DRG SUBMITTAL
G0.1
 Plotted On: 5/26/22

COVER SHEET

CABIN 10 EXISTING-DEMO & PROPOSED FIRST FLOOR PLAN

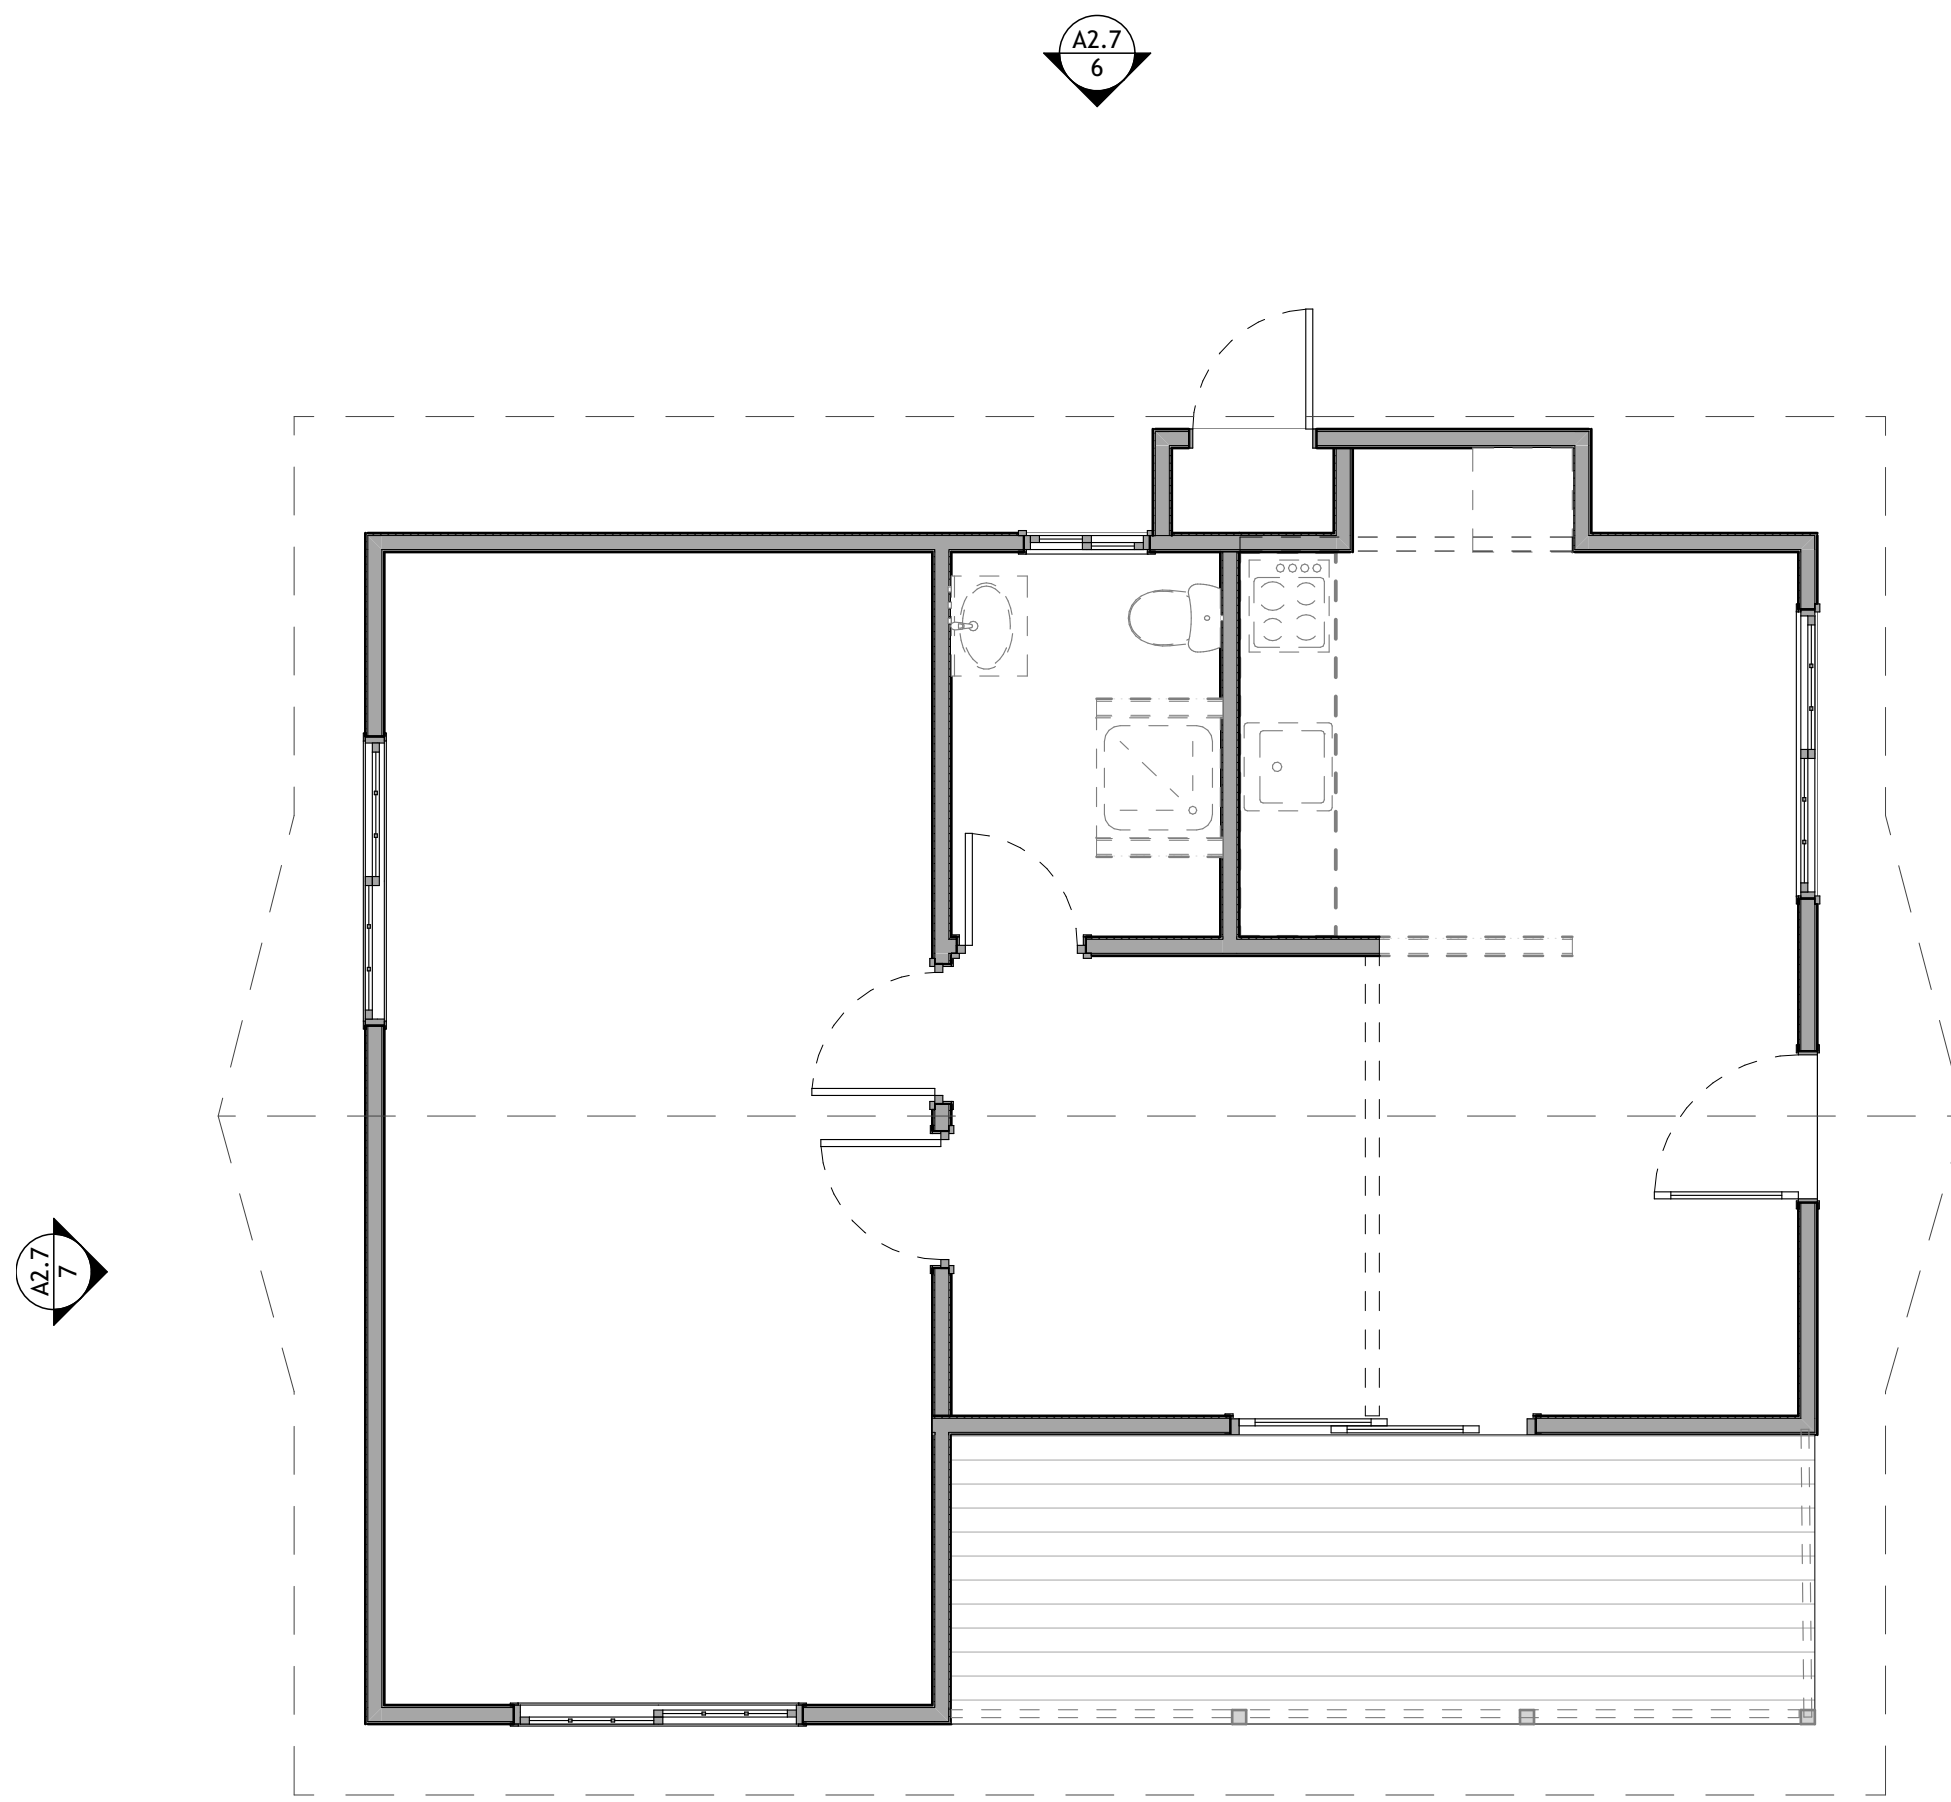
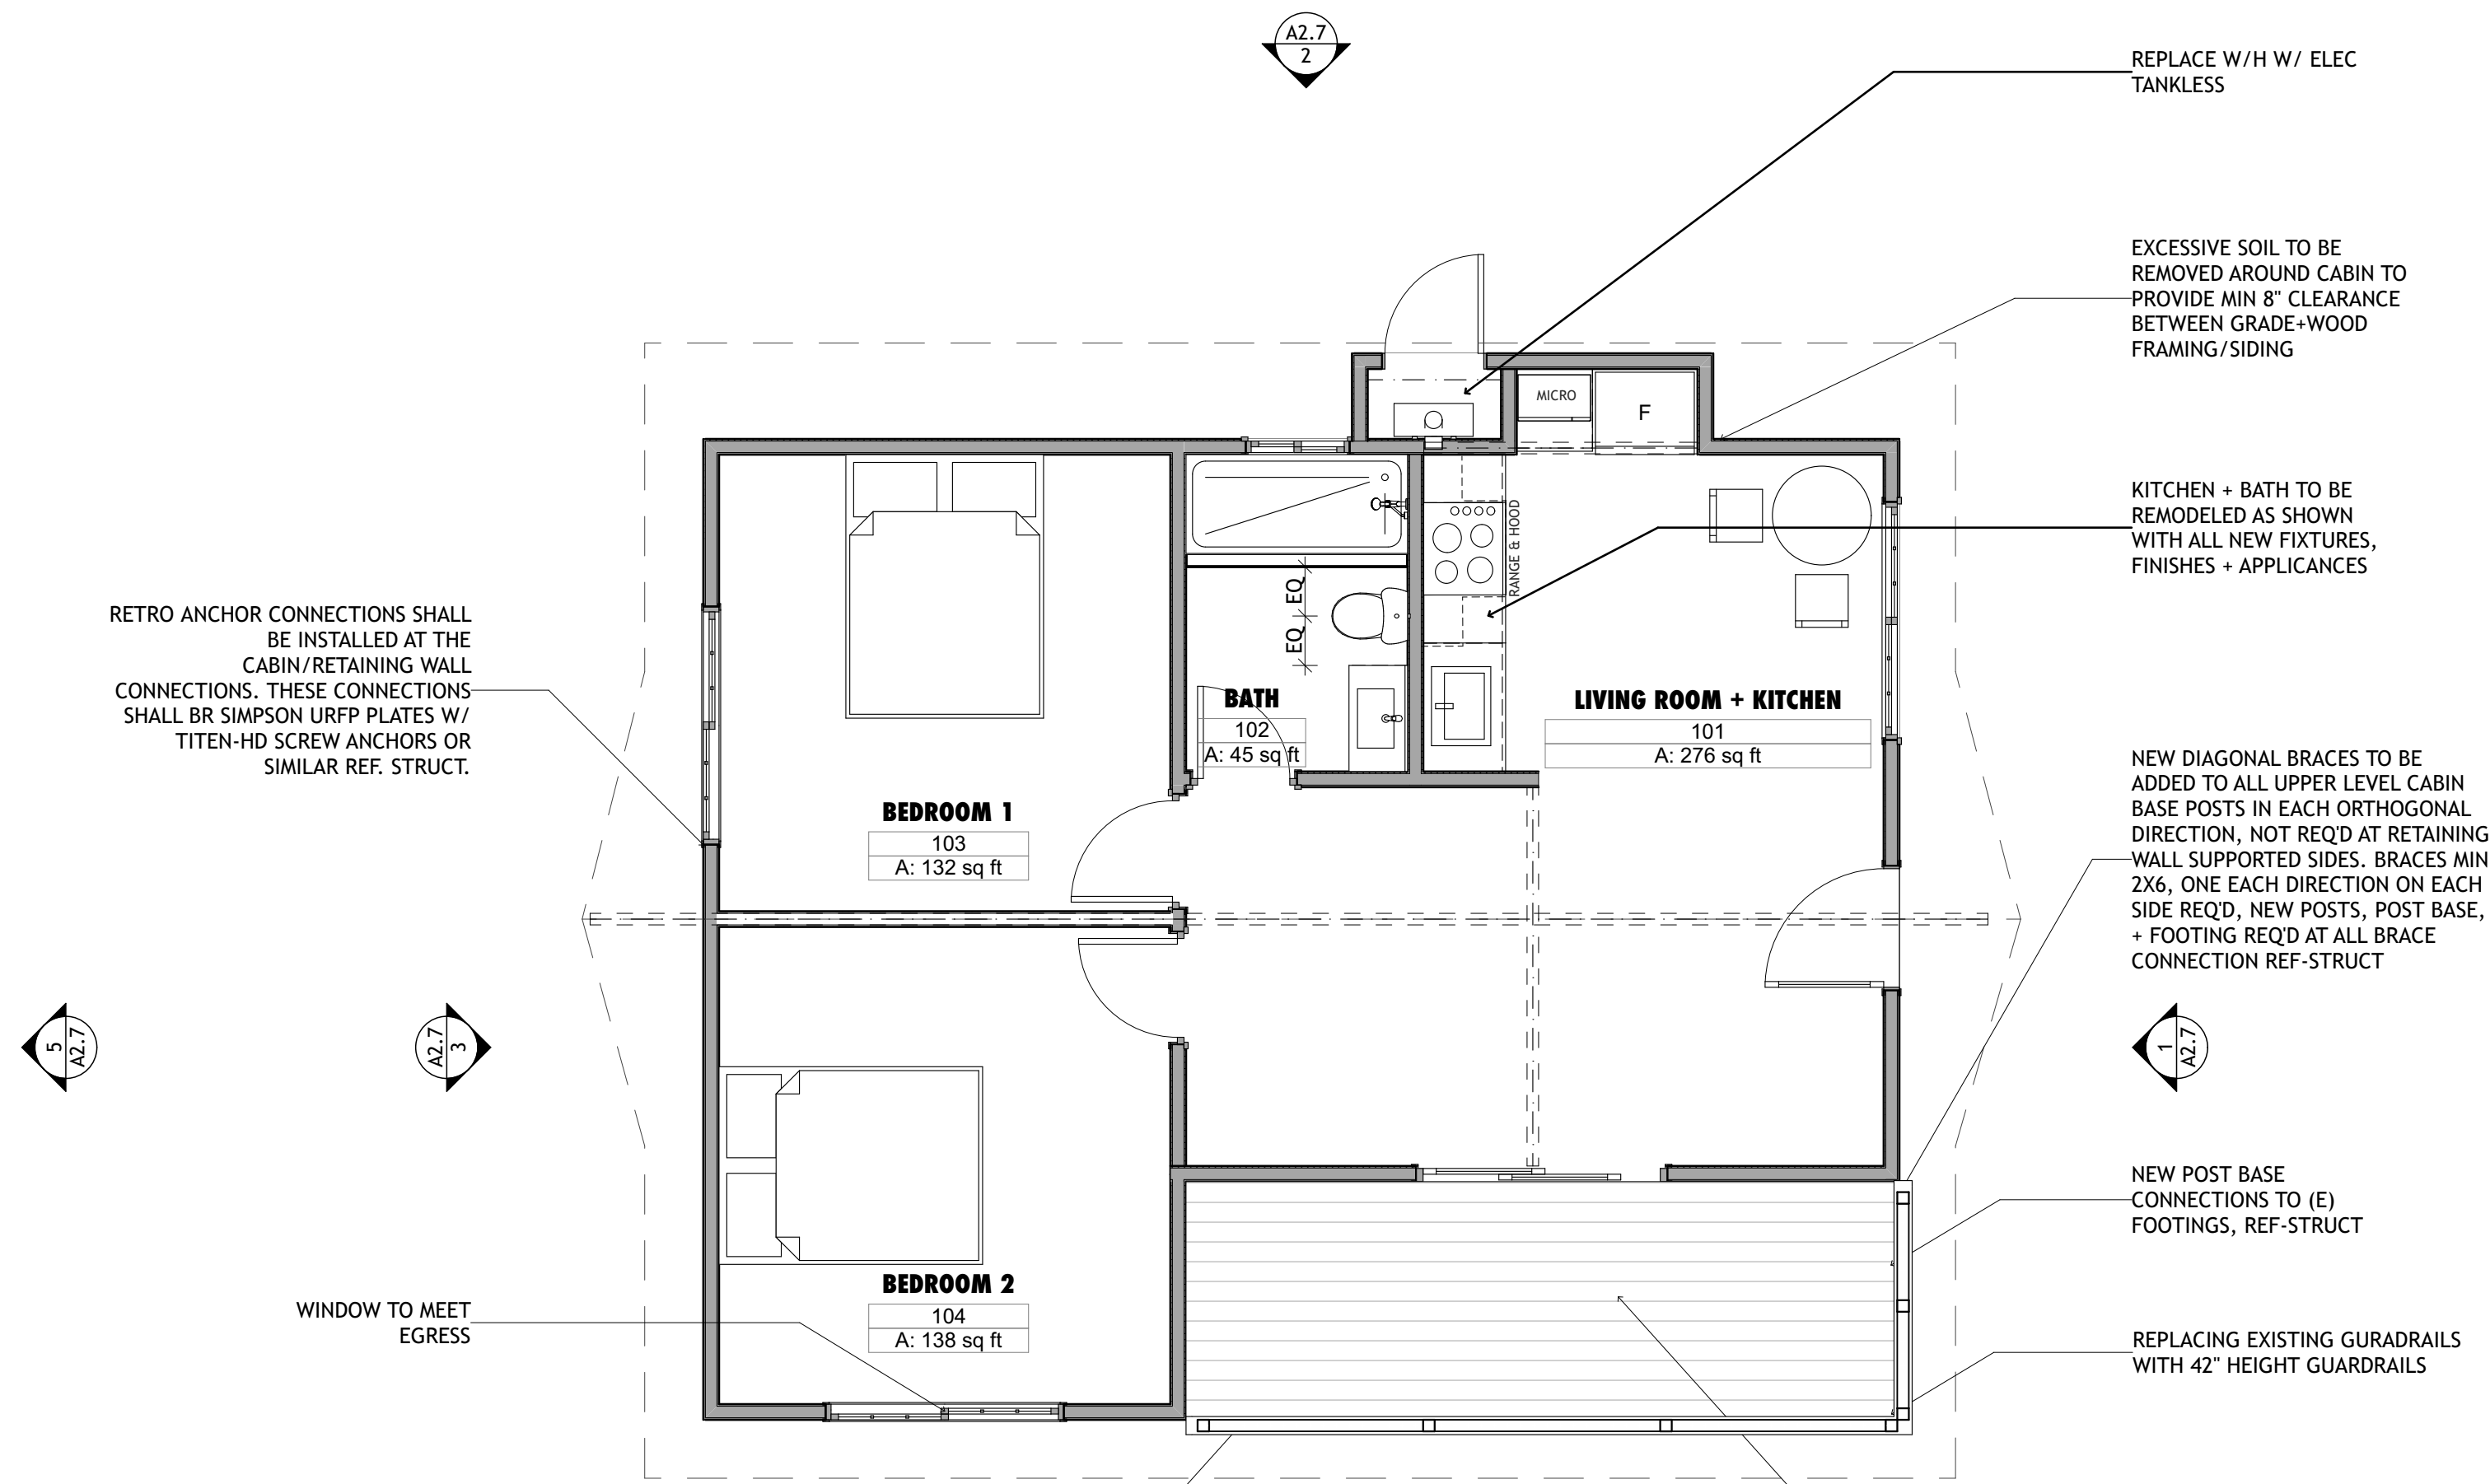
REPLACE W/H W/ ELEC TANKLESS

EXCESSIVE SOIL TO BE REMOVED AROUND CABIN TO PROVIDE MIN 8" CLEARANCE BETWEEN GRADE+WOOD FRAMING/SIDING

NEW DIAGONAL BRACES TO BE ADDED TO ALL UPPER LEVEL CABIN BASE POSTS IN EACH ORTHOGONAL DIRECTION, NOT REQD AT RETAINING WALL SUPPORTED SIDES. BRACES MIN 2X6, ONE EACH DIRECTION ON EACH SIDE REQD. NEW POSTS, POST BASE, + FOOTING REQD AT ALL BRACE CONNECTION REF-STRUCT

ALL DECKING TO BE ANALYZED FOR CODE LOADING. NEW DECK BEAM W/ FOOTING SUPPORTS SHALL BE ADDED WHEN DECKING IS FOUND TO BE OVERSTRESSED. ALL WEATHER-DAMAGED DECKING TO BE REMOVED + REPLACED. REF STRUCT.
